Reference: Docket No. 10-BSTD-01
June 10, 2011 Staff Workshop – 2013 Building Energy Efficiency Standards

On behalf of the members of the EPDM Roofing Association [ERA], I am writing to respectfully voice our concern with the proposed changes to the 2013 Title 24, part 6, as originally presented in the Non-residential Cool Roof Stakeholders Webinar on June 1, 2011, presented at the Staff Workshop on Jun 10, 2011, and in subsequent communications to the roofing industry coalition through Reed Hitchcock. ERA is a trade association that represents the manufacturers of EPDM single-ply rubber roofing membrane, which has been extensively used by the low-slope commercial roofing industry for over 40 years.

Energy Usage Comparison

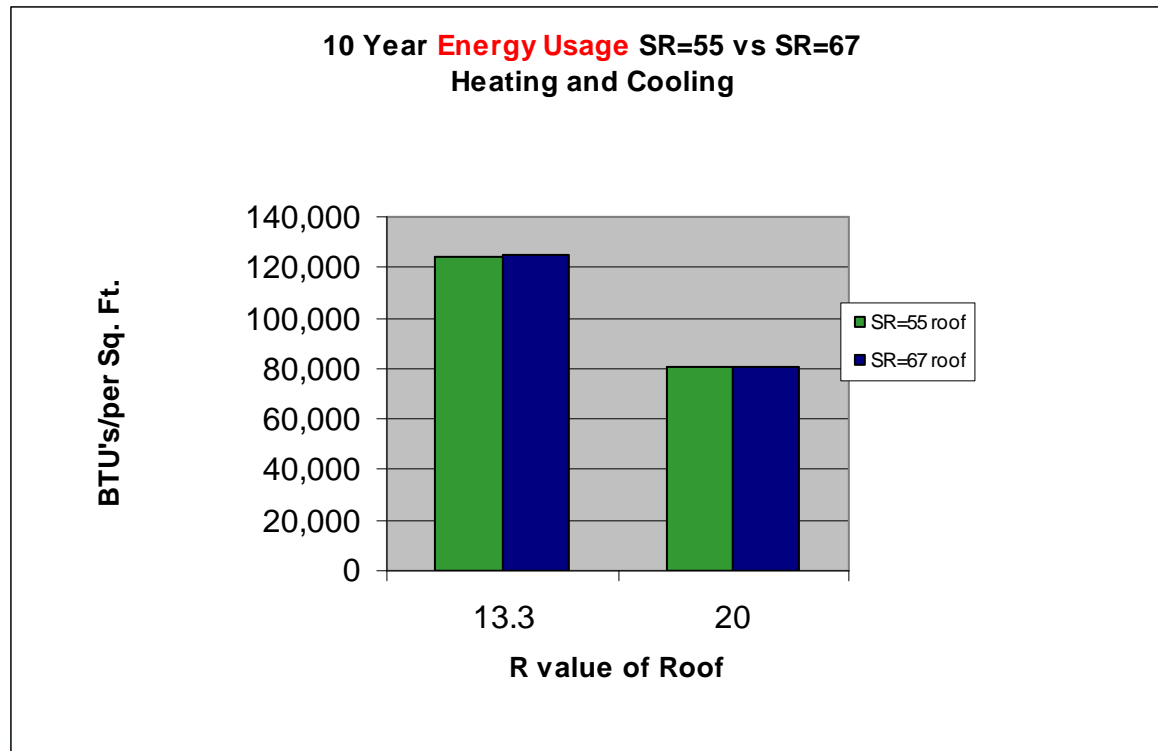
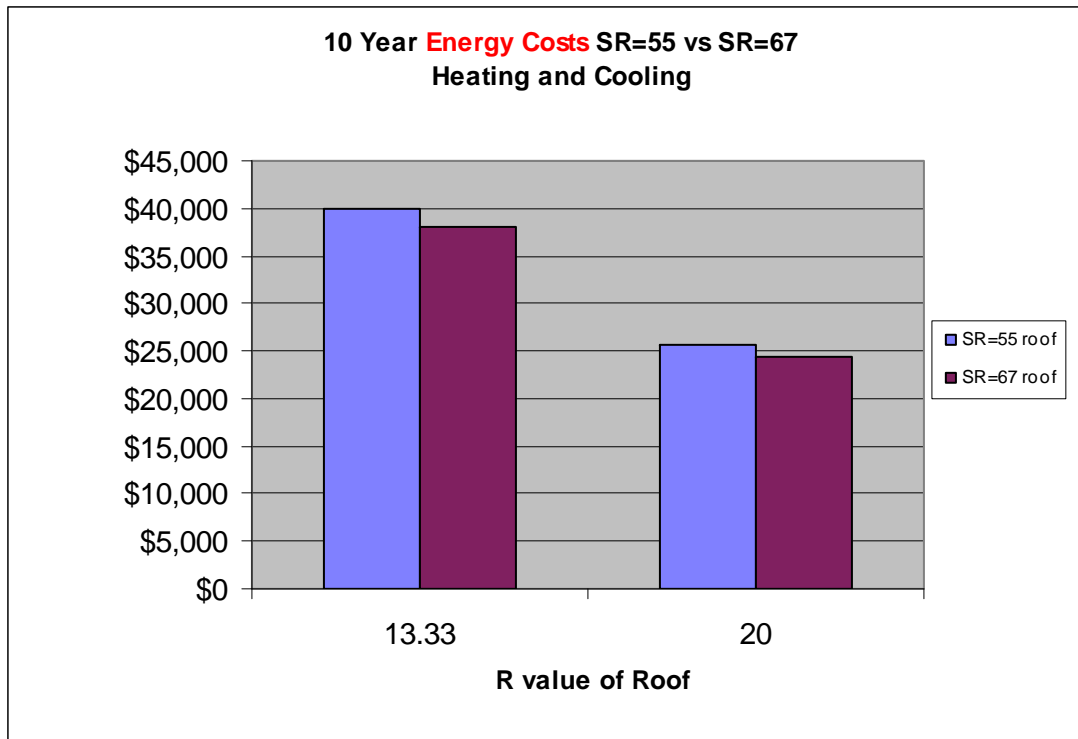
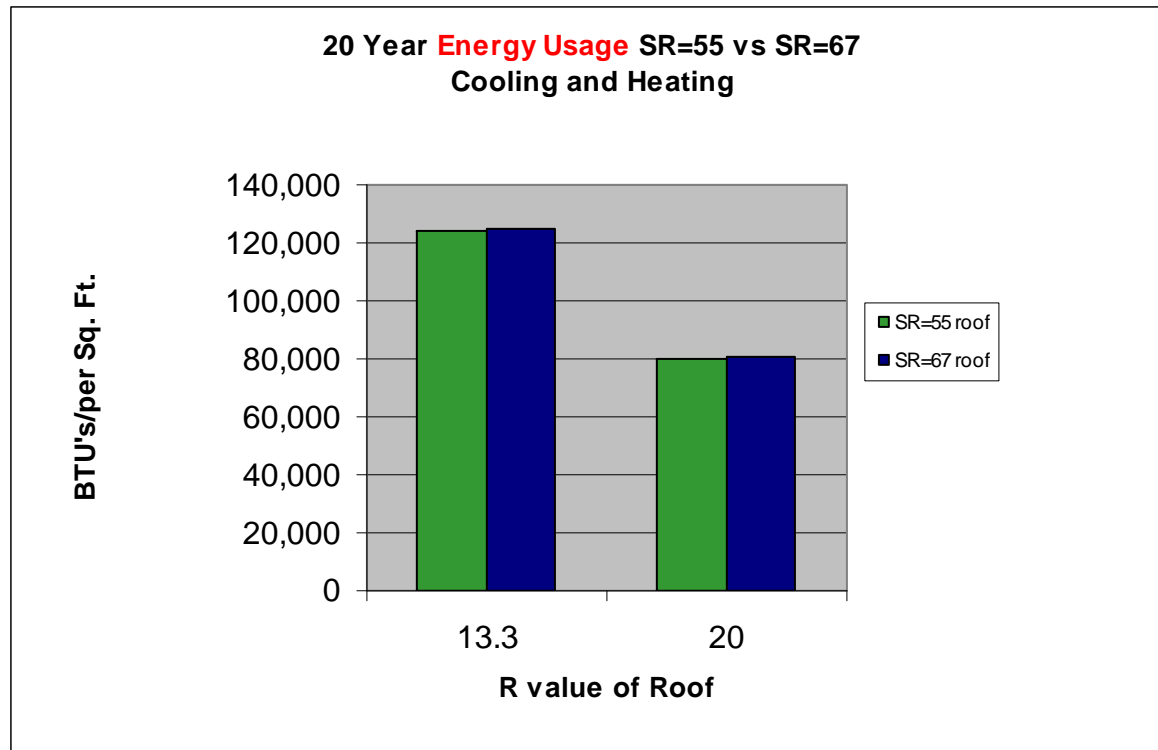
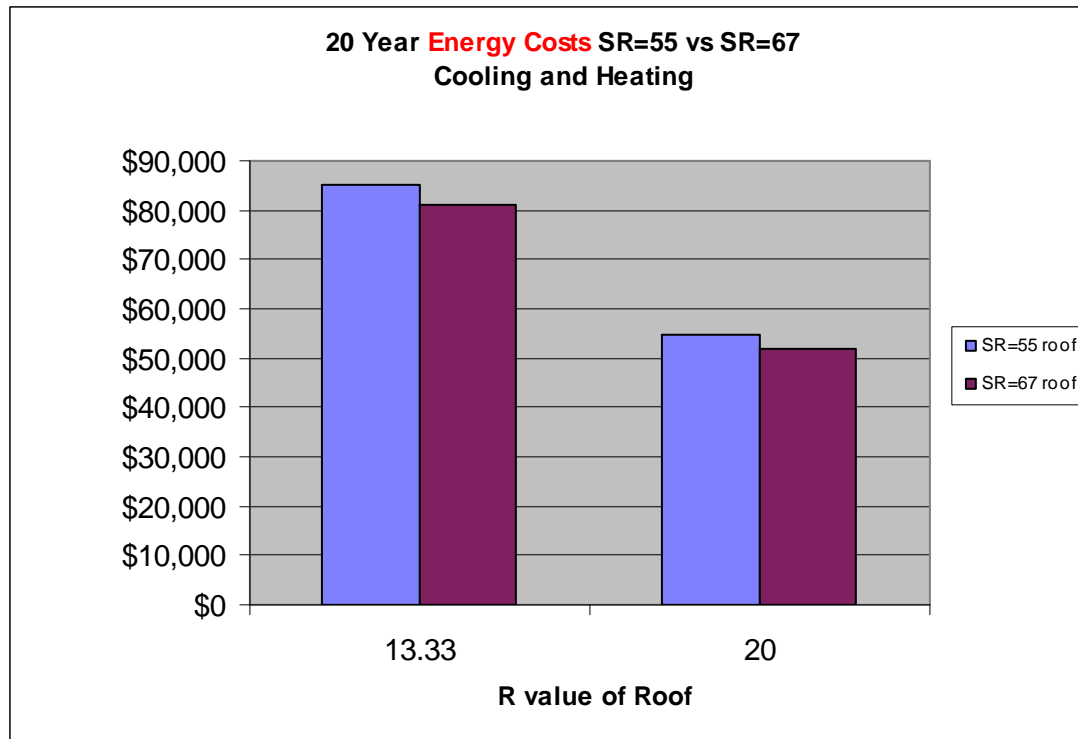
- It is our understanding that the impetus for these code revisions is based solely on procuring energy reduction (a reduction in energy usage), and thus it is an energy conservation measure. A long held, but incorrect assumption is the roof color contributes substantially to energy usage reductions. Attached are slides showing energy usage and energy cost data for two scenarios: Using the DOE calculator and the data you provided Mr. Hitchcock, Solar Reflectance values of .55 and .67, with insulating R values of R13.3 and R20.0; for Los Angeles and San Francisco. The data indicates that both over 10 year and 20 year periods that insulation has a greater impact on the reduction in the use of energy than does roof reflectance.
